**LONG BEACH CITY COLLEGE DISTRICT
CONTRACTS MANAGEMENT DEPARTMENT**

**BID C2194A ADA SITE BARRIER REMOVAL PROJECT
AT THE
LIBERAL ARTS CAMPUS**

ADDENDUM NO # 1

OCTOBER 19, 2020

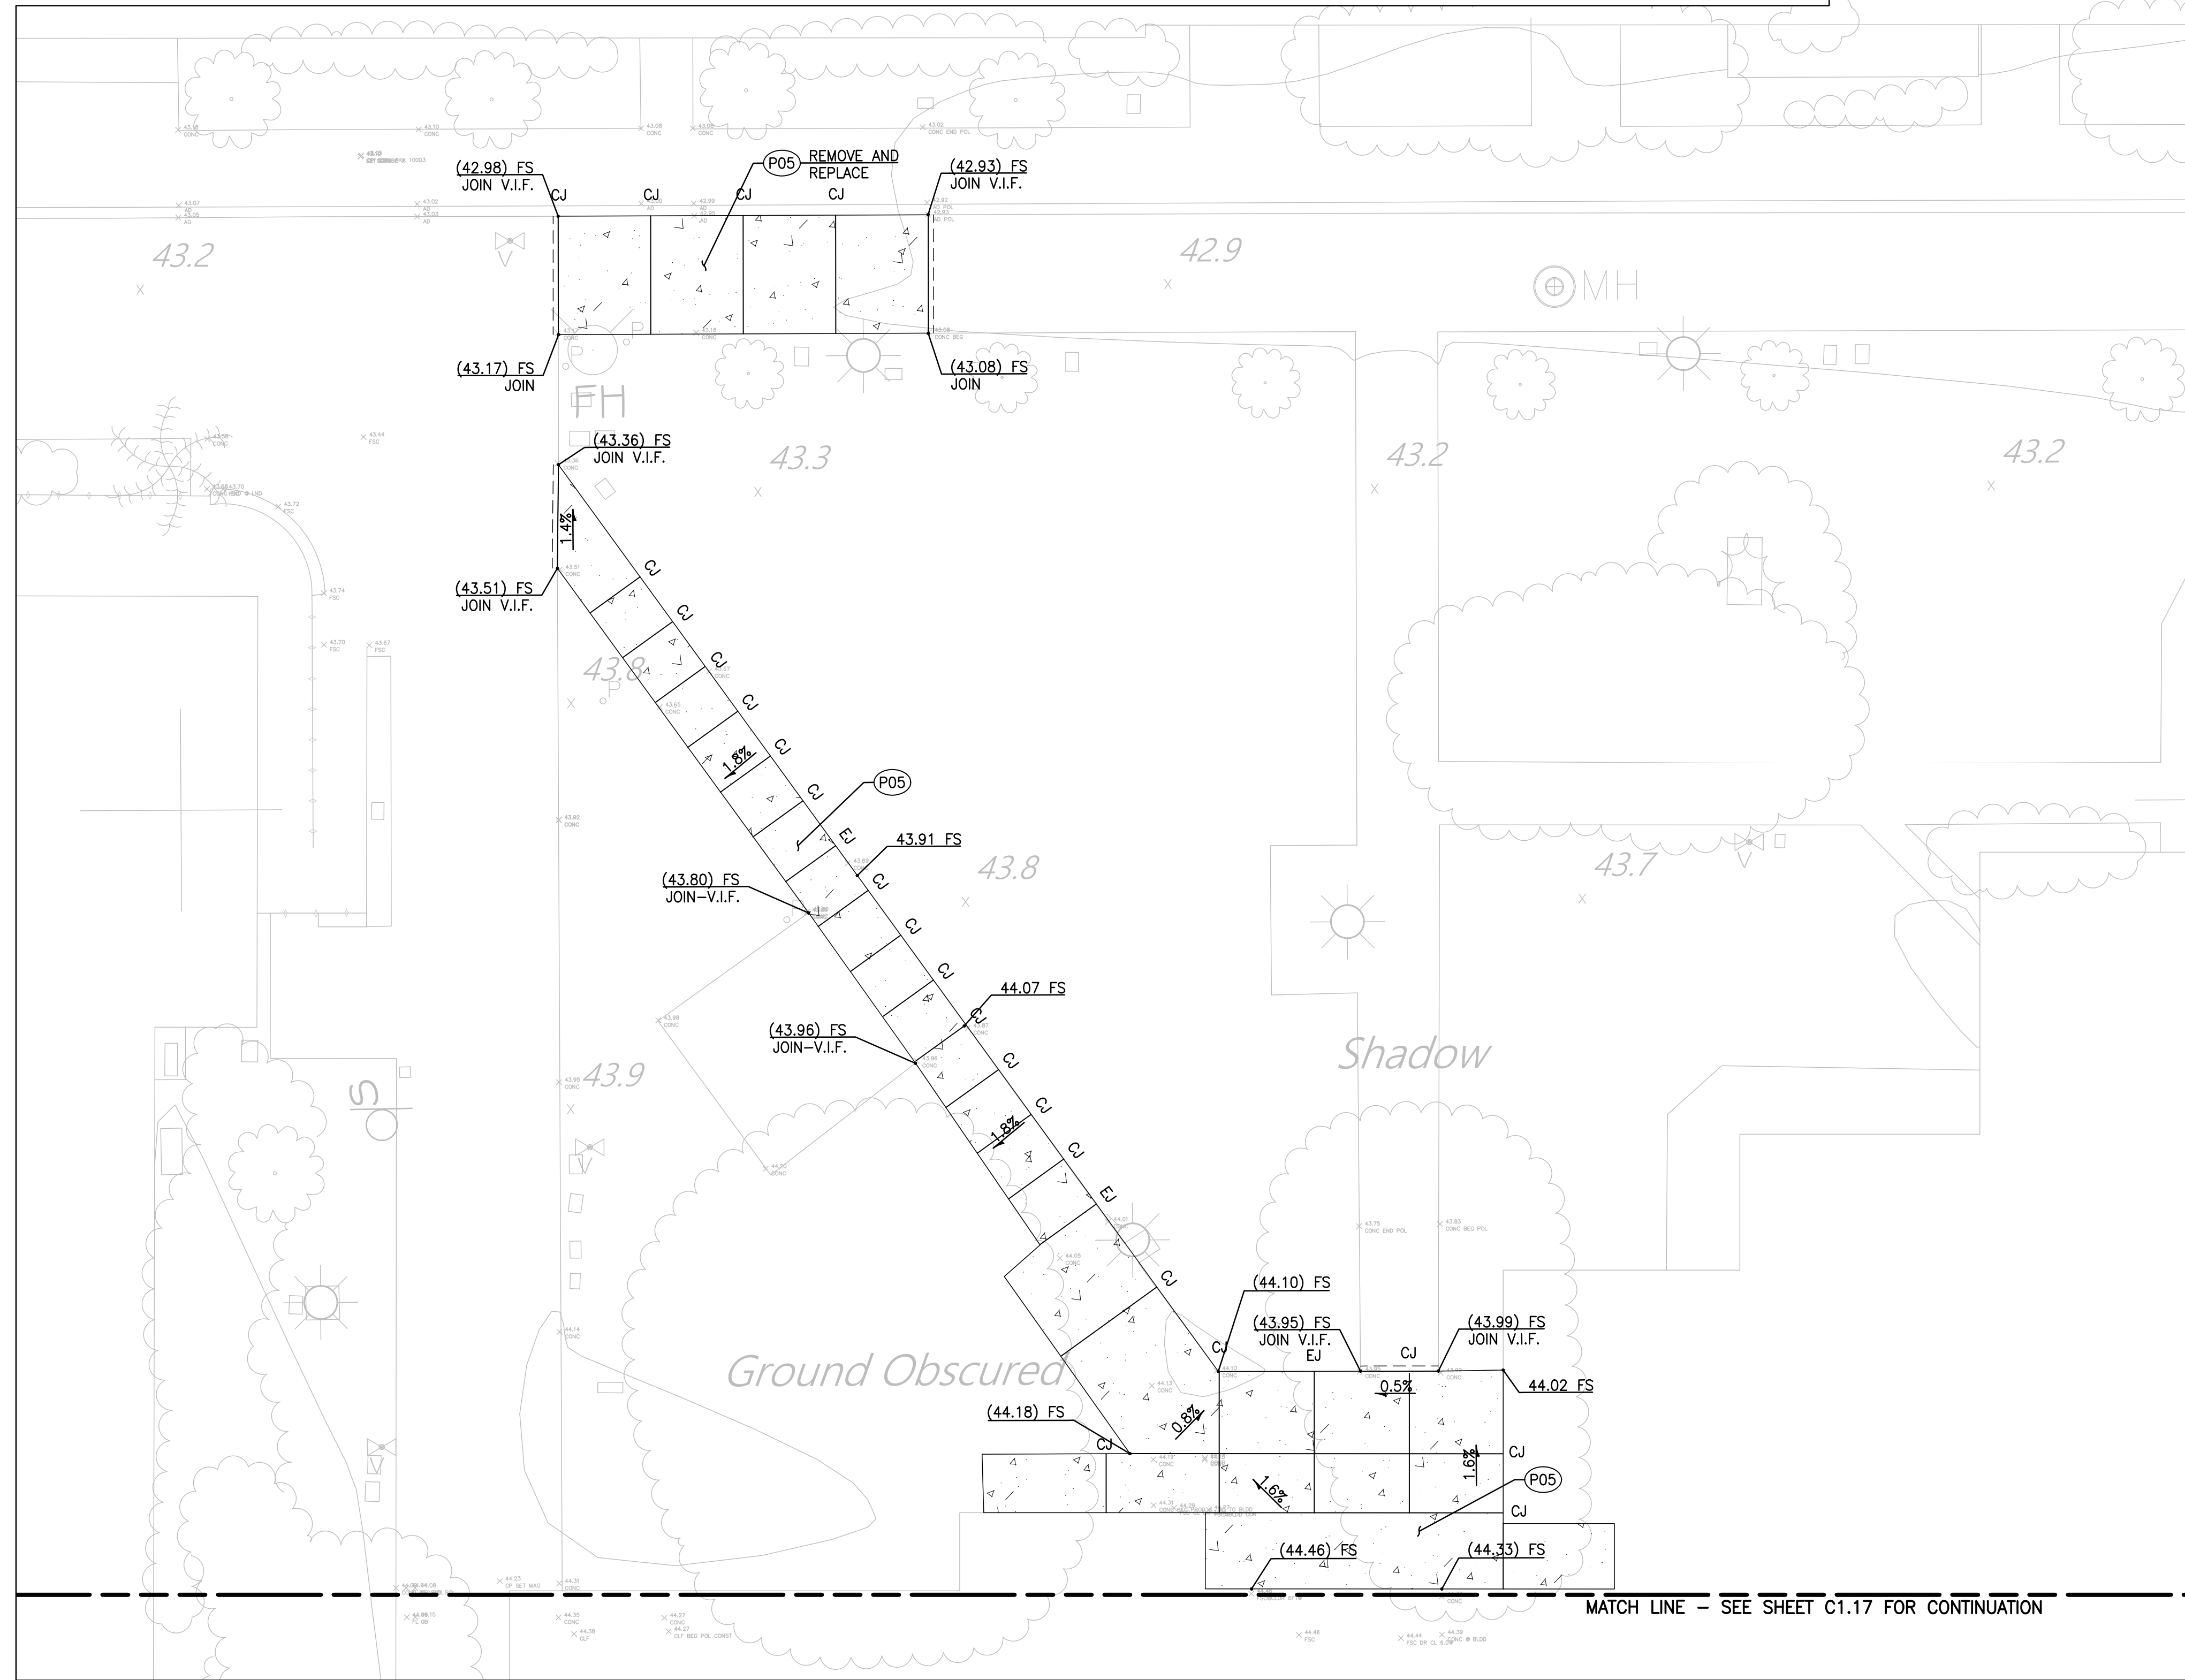
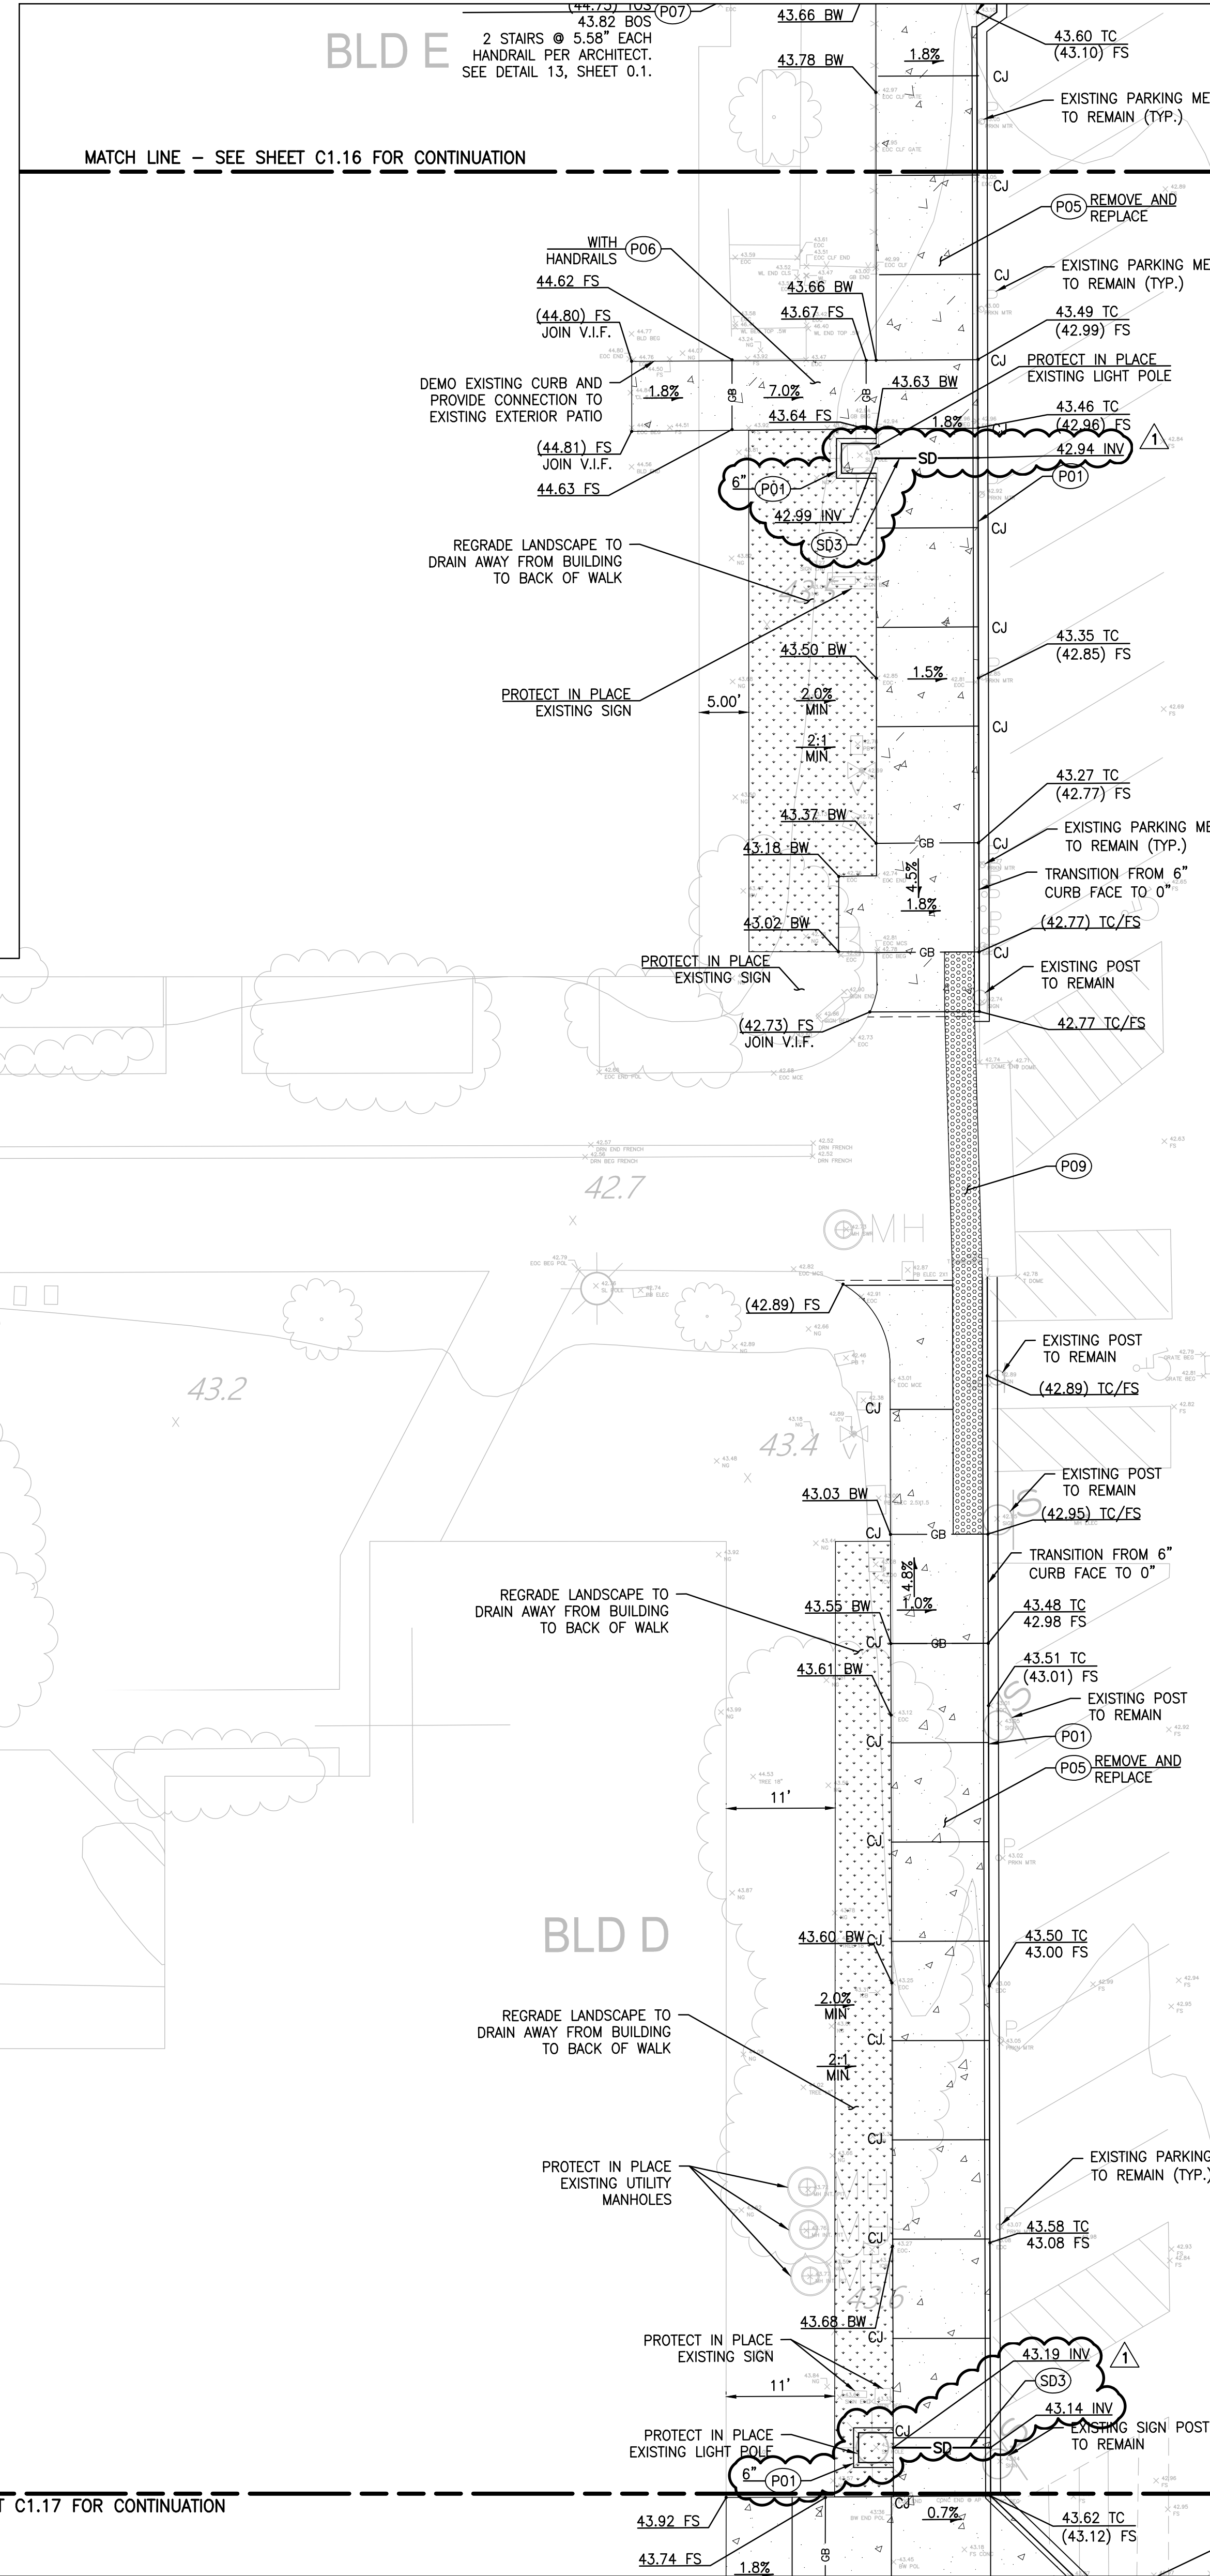
4. Q: C1.15 – In front of Building E, there is a drain in the back of sidewalk the plans make no mention of it? What happens with this drain?

A: Drain to be removed and replaced with new drain body. Tie into existing inlet and outlet connections. At the wall above the existing trench drain, there are four existing weepholes: two existing 1" weepholes and two existing 2.5" weepholes. The 1" weepholes shall be plugged as they will be below the proposed back of walk. See Addendum 1 Sheet C1.15.
